Applicant requests a Special Exception under Section 2.16.050 Q (Carport over a Driveway) in an R-5 zone of the City of El Paso Zoning Ordinance.

This would permit the construction of a 20.8' by 16' portion of a carport located 4' from the front property line.

ITEM #2

| 9312 NOTTINGHAM DRIVE LOT 21, BLOCK B, LANCASTER ADDITION UNIT J CITY OF EL PASO, EL PASO COUNTY, TEXAS | | | | | |

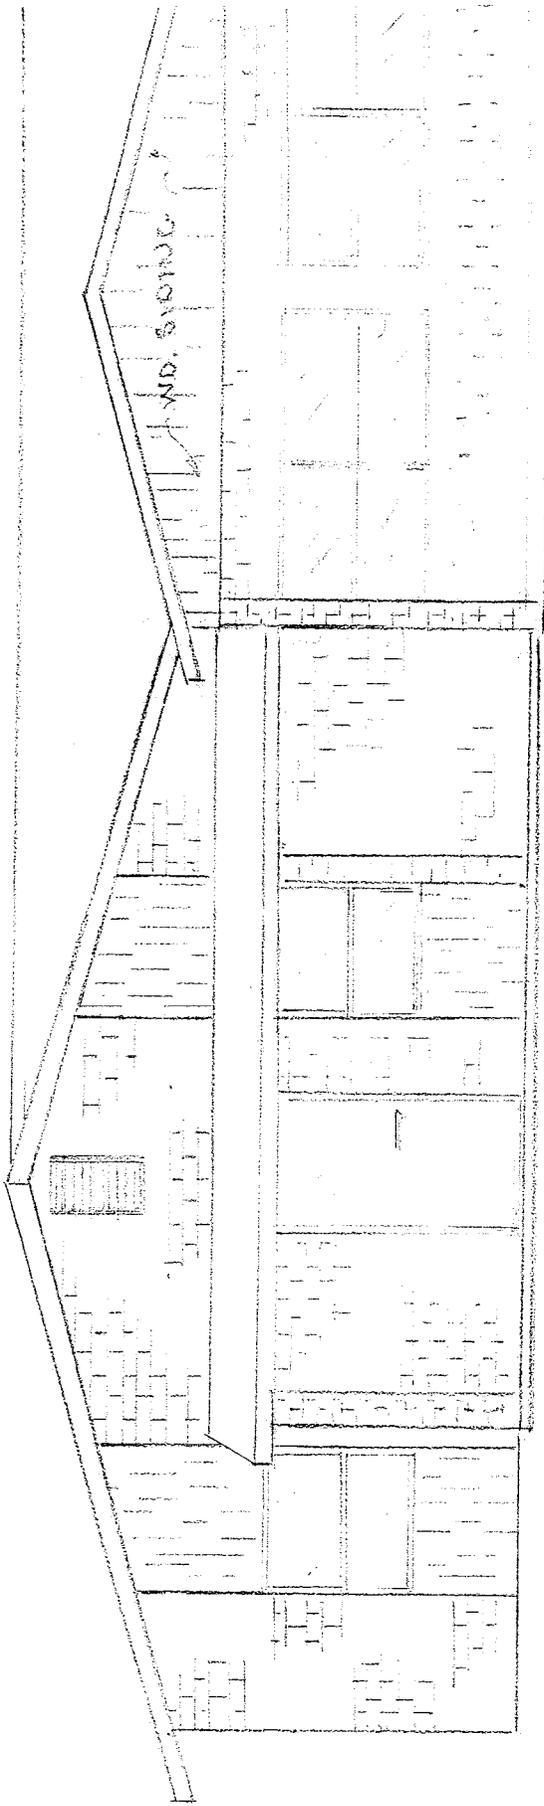
The area of the portion of the requested carport that is encroaching in the setback is 332 sq. ft. The first floor area under roof, including a front porch to be added, is 1,733.25 sq. ft. (1,591 sq. ft. + 142.25 sq. ft.). The maximum permitted area of encroachment is 346 sq. ft. (1,733.25 ÷ 5). The Development Services–Building Permits and Inspections Division and the Engineering Department–Traffic Division have reviewed the plans for the proposed carport and have no apparent concerns with the structure, but note that carports shall not encroach onto sidewalks.

Staff recommends approval the Special Exception Q (Carport over a Driveway) with the condition that the applicant revises the drawings to show the reduction of the overhang when obtaining building permits.
